Planning Commission Staff Report

Subject: Rezoning Vote Report

Petition: P.Z. 42-2007 Spirit Valley Business Park II

RE: P.Z. 42-2007 — Spirit Valley Business Park II (18730 Olive Street Road)

SPIRIT VALLEY BUSINESS PARK II
PRELIMINARY SITE PLAN

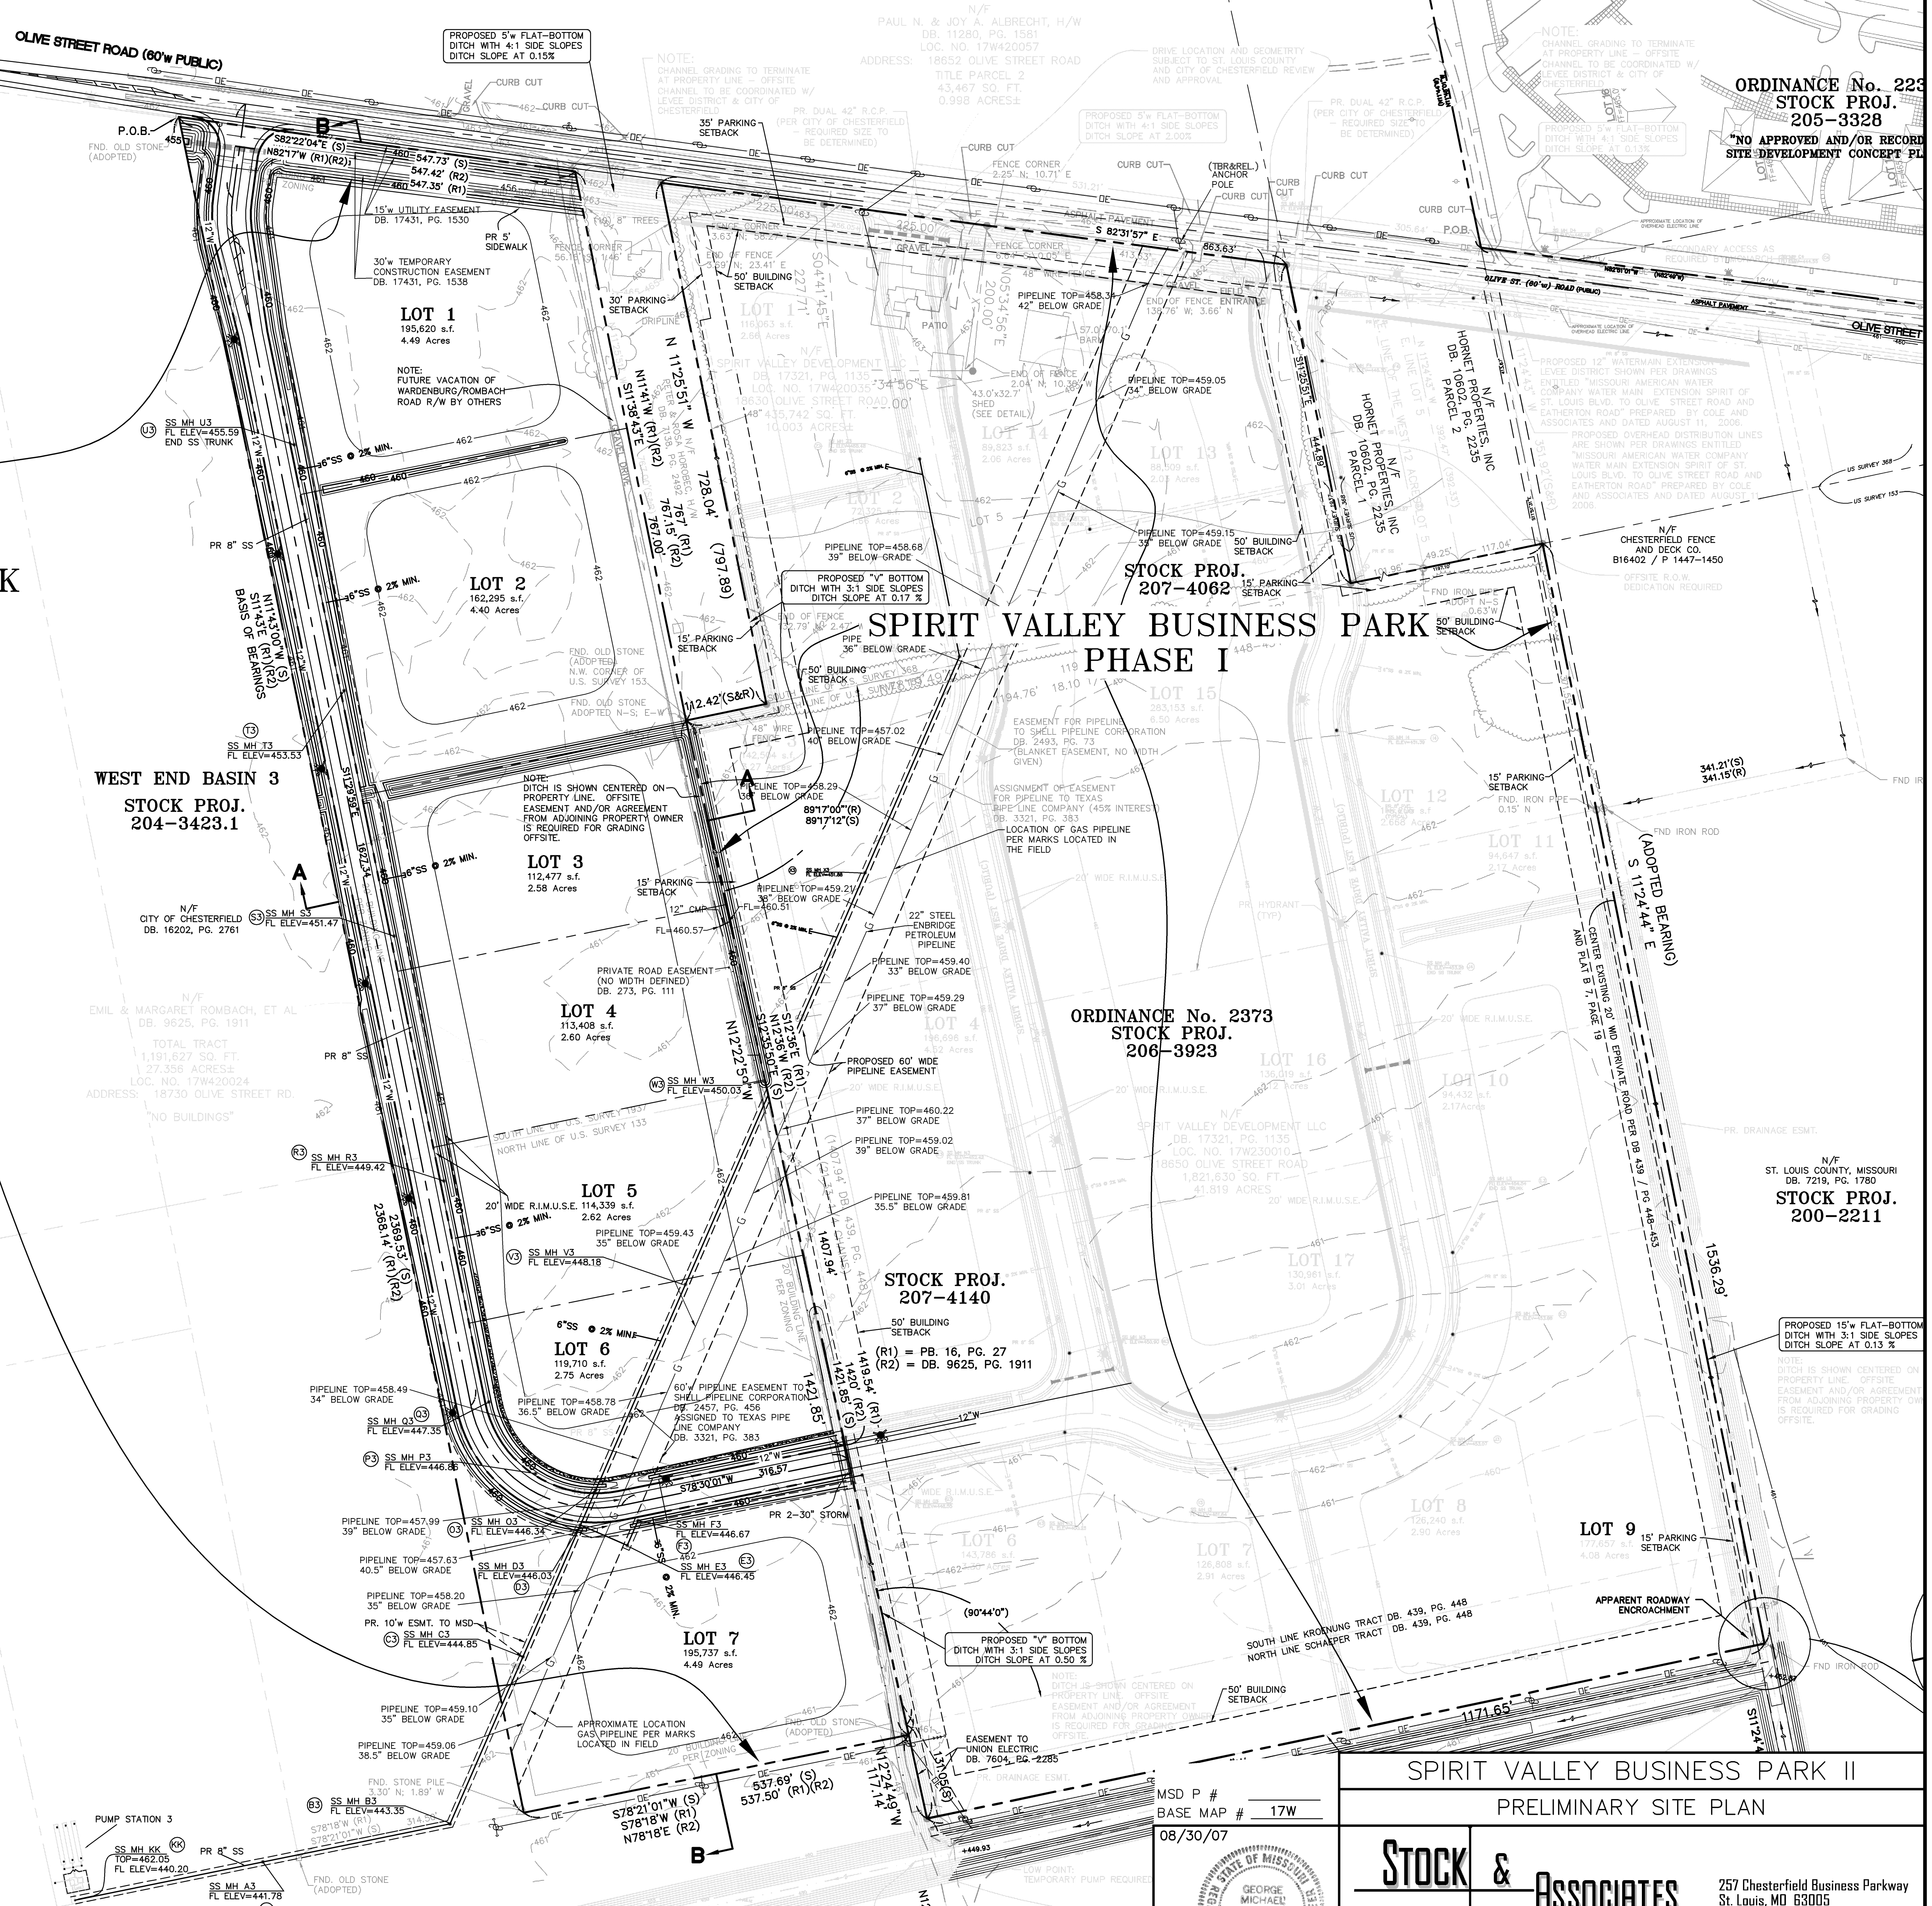
- An exclusive 20 foot Chesterfield Valley Storm Water Easement is required along the western property line for a distance of 500 feet from the Olive Street Road right of way. The preliminary plan appears to depict a proposed water main within an exclusive 10 foot easement. Please be advised that based upon this layout the proposed internal road would require a 10 foot shift to the east to accommodate both easements. This issue will be addressed during review of the Site Development Plan.

- The current plan depicts a 20 foot spite strip along the western property line. All area between the right of way and western property line must either be dedicated as right of way or a cross access easement dedicated such that the spite strip is eliminated. Please keep in mind this issue must also be coordinated with the required 20 foot wide Chesterfield Valley Storm Water Easement required along the western property line. The issue will be addressed during review of the Site Development Plan.

- The typical section provided for the internal roadway system omitted sidewalks from both sides of the roadway. The sidewalks should be located outside the roadway improvement, maintenance, utility, and sewer easement adjacent to the right of way.

Response: Acknowledged.

Response: Acknowledged.

Response: Acknowledged.
